# NORTH TEXAS MUNICIPAL WATER DISTRICT

## LAKE SIDE INTERCEPTOR REPLACEMENT

PROJECT NO. SRWWPCF 07-1(102)

### CONFORMED SET

**PLAN AND PROFILE**  
 STA. 44+00 TO STA. 49+00

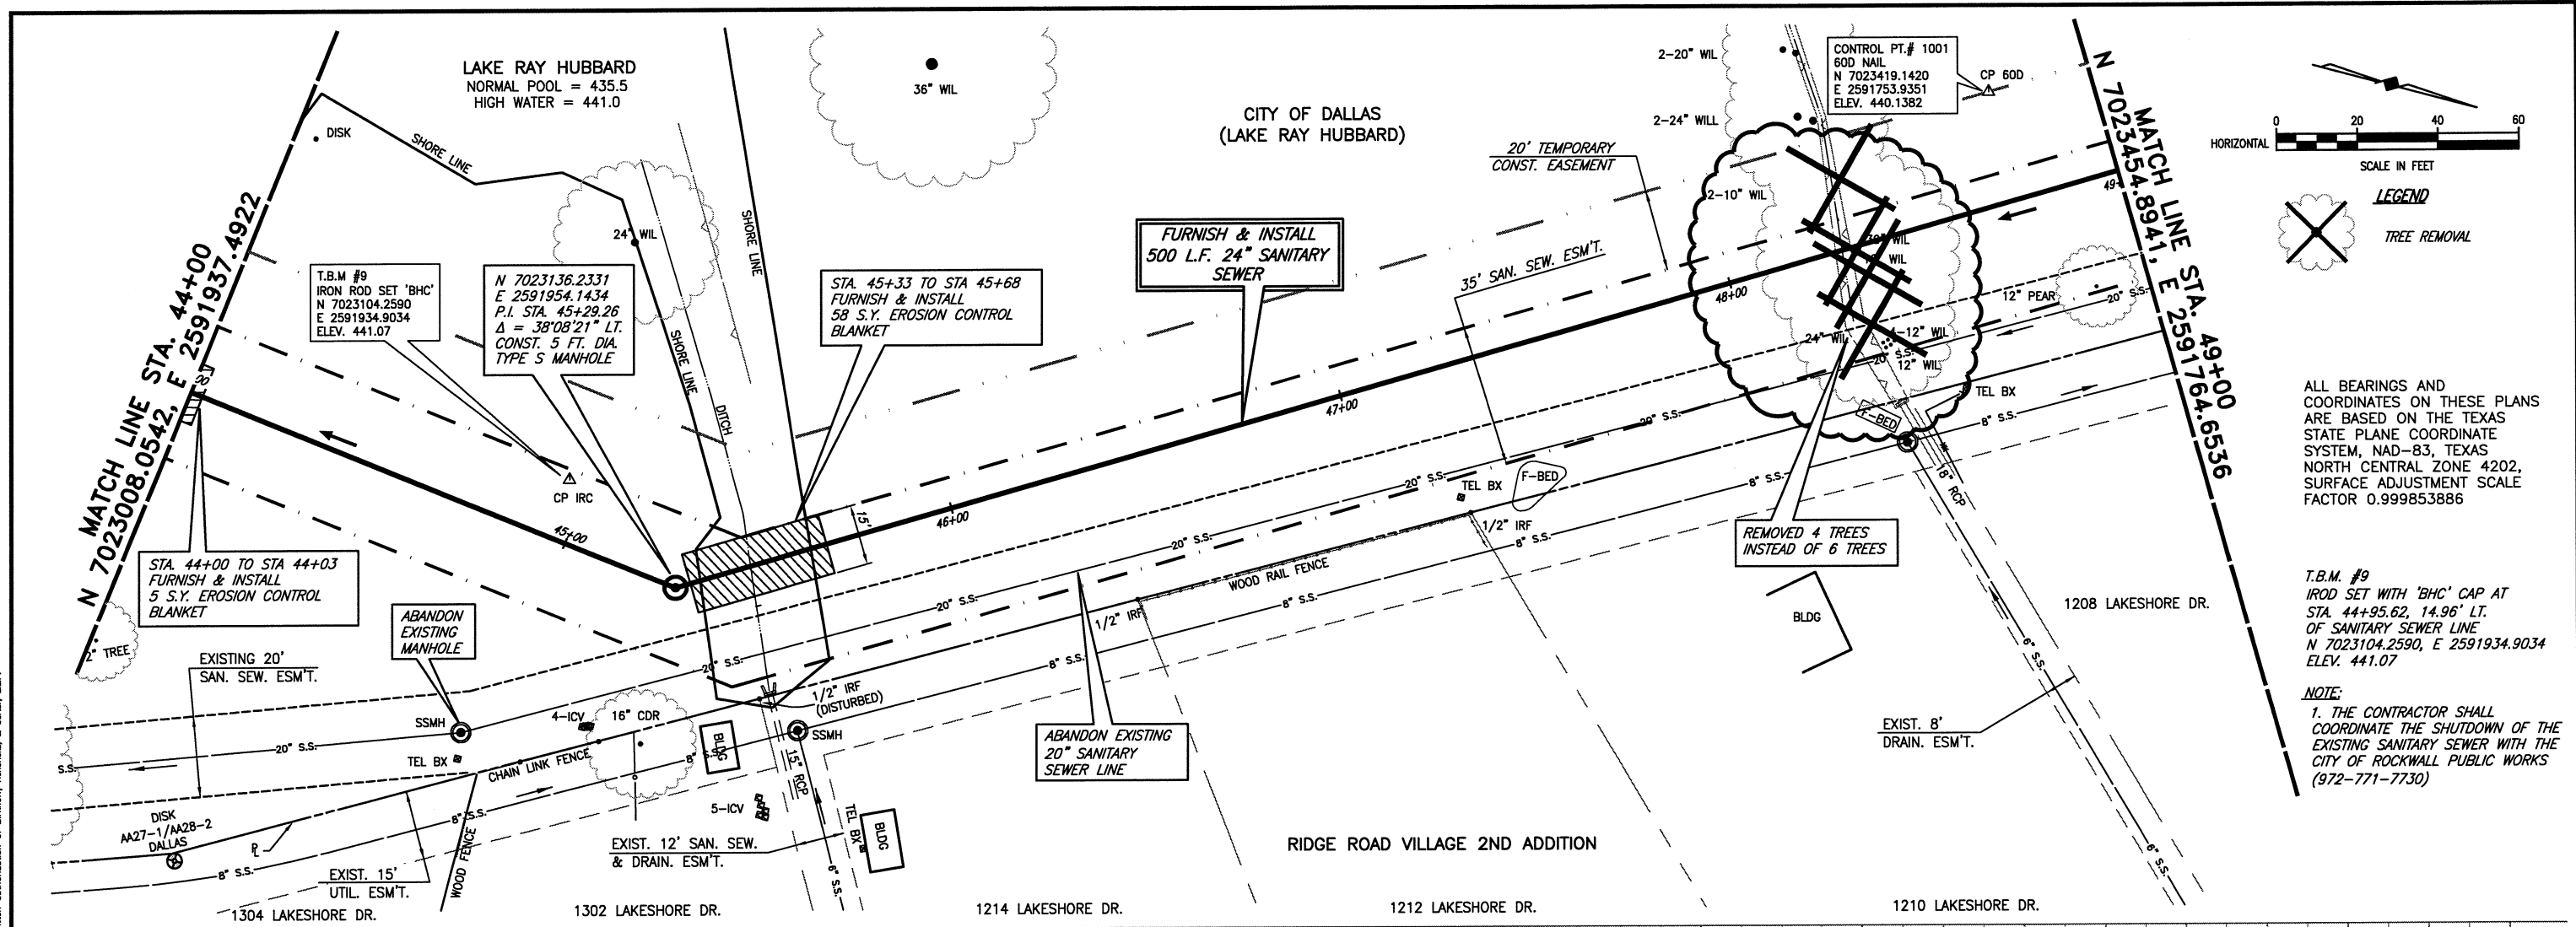
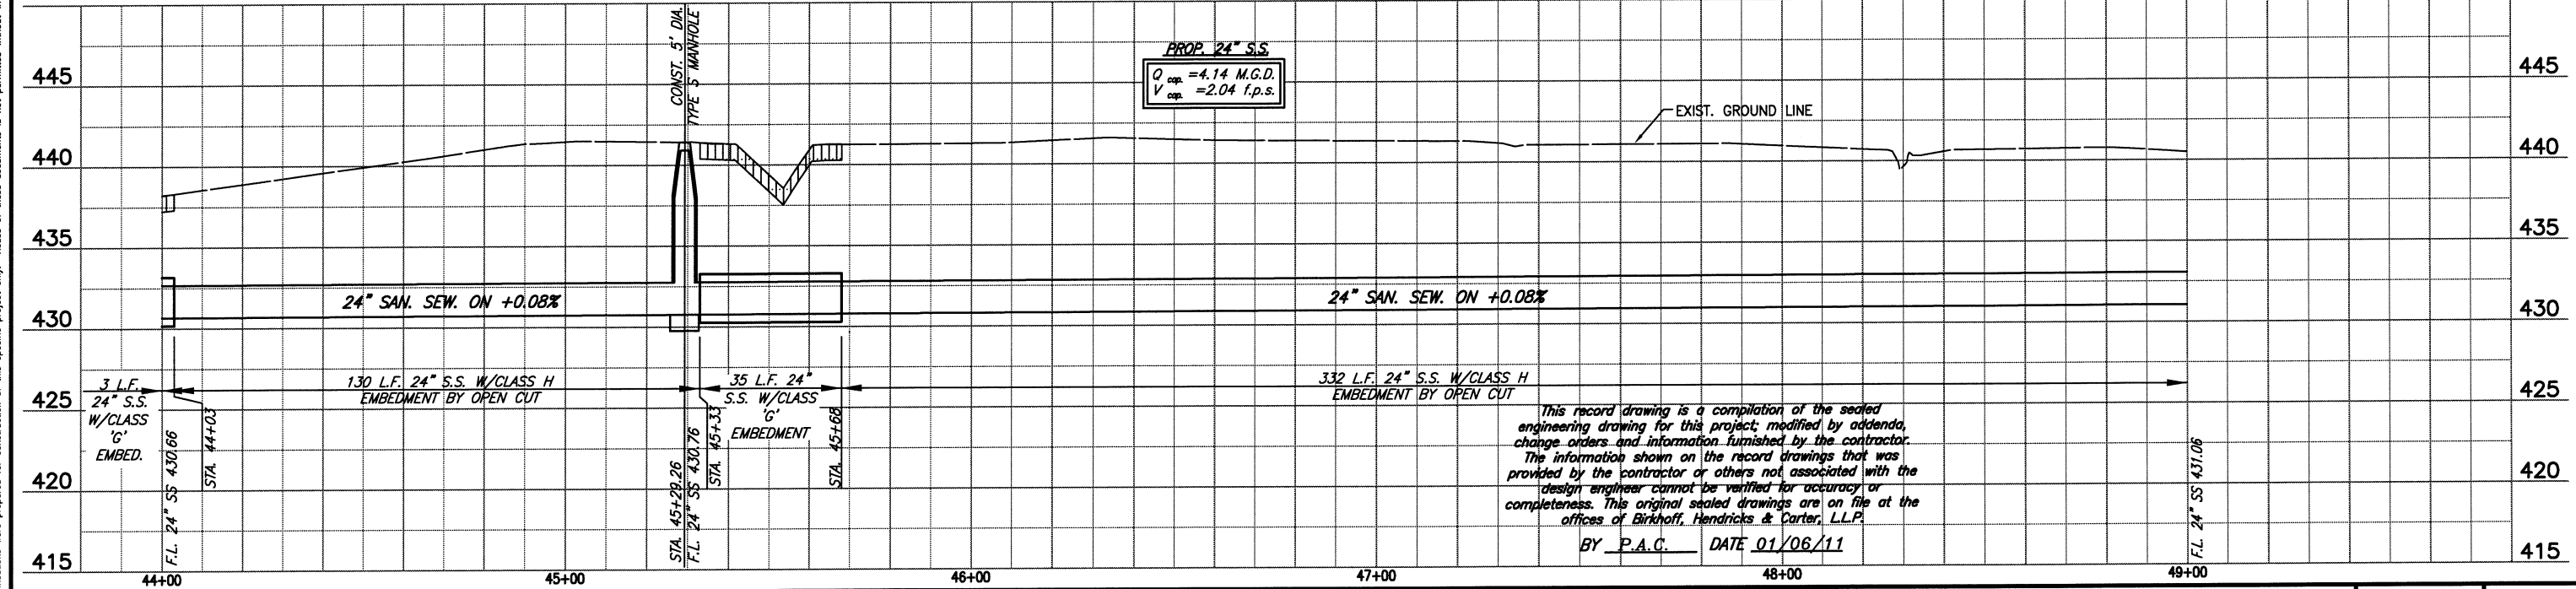
FIELD CHANGE NO.2 2/12/09 - REVISED TREE REMOVAL LOCATIONS
CHANGE ORDER NO.1 2/12/09 - REVISED BORE LOCATIONS & ENCASEMENT
FIELD CHANGE NO.4 6/29/09 - REVISED VERTICAL ALIGNMENT

**PLAN AND PROFILE**  
 STA. 49+00 TO STA. 54+00

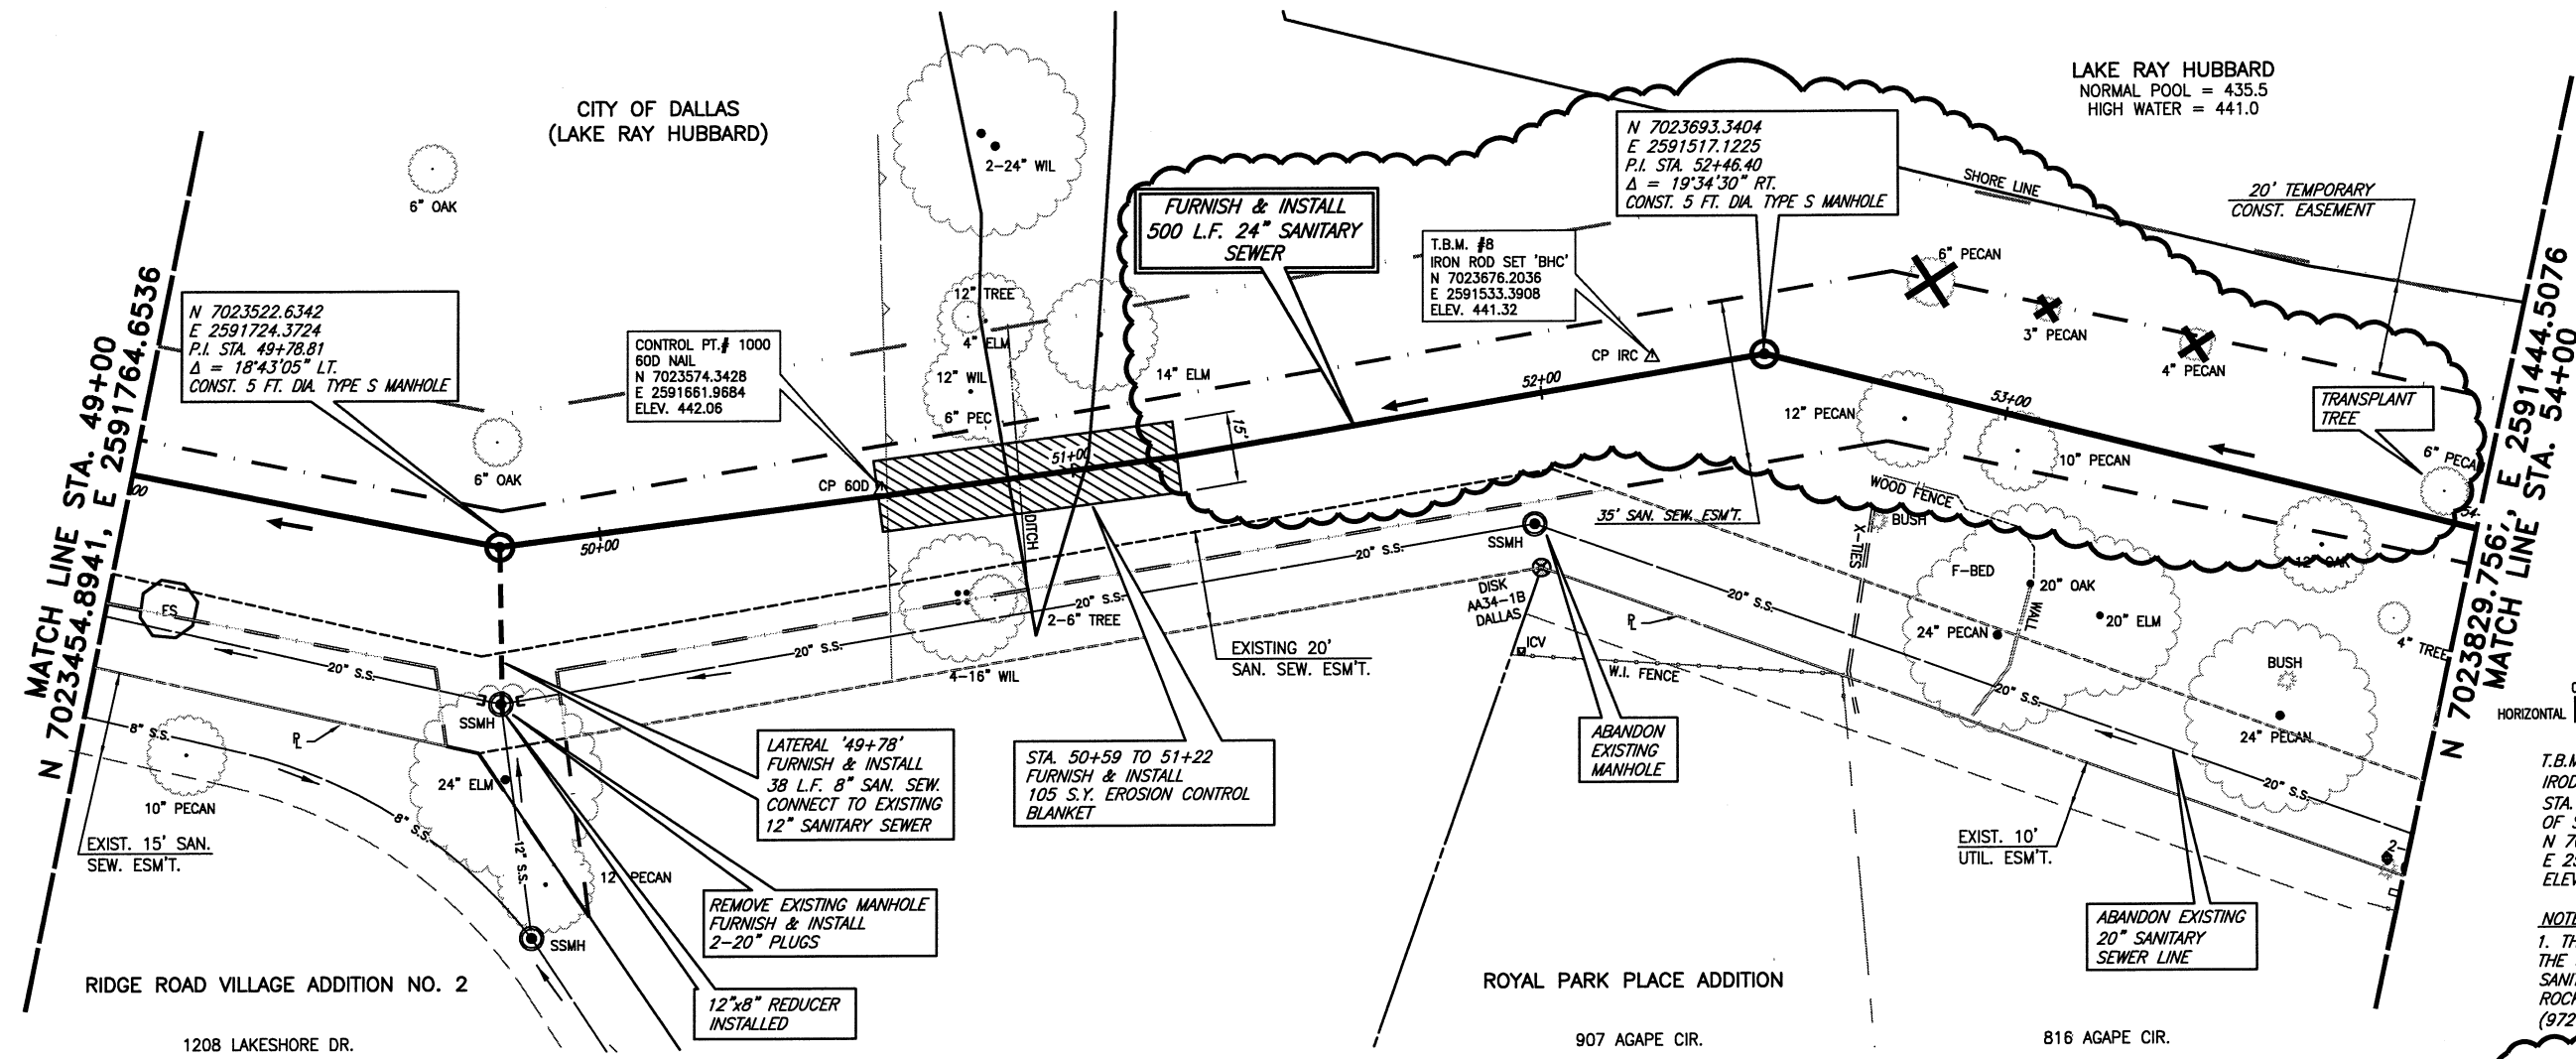
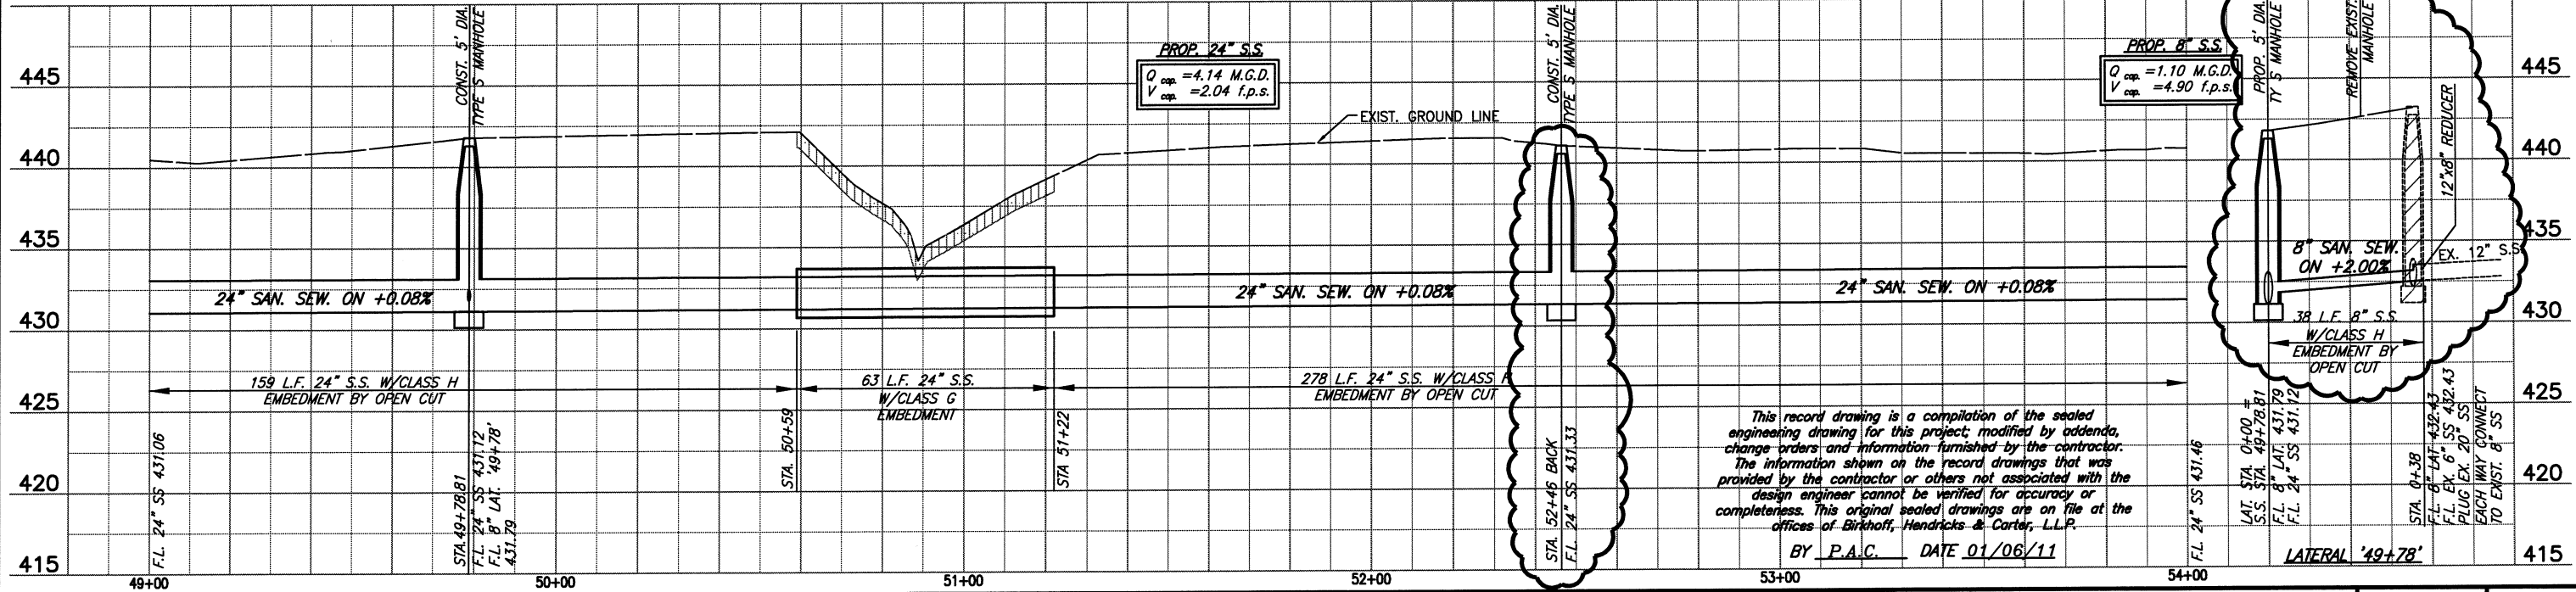
FIELD CHANGE NO.2 2/12/09 - REVISED TREE REMOVAL LOCATIONS
FIELD CHANGE NO.4 6/29/09 - REVISED VERTICAL ALIGNMENT
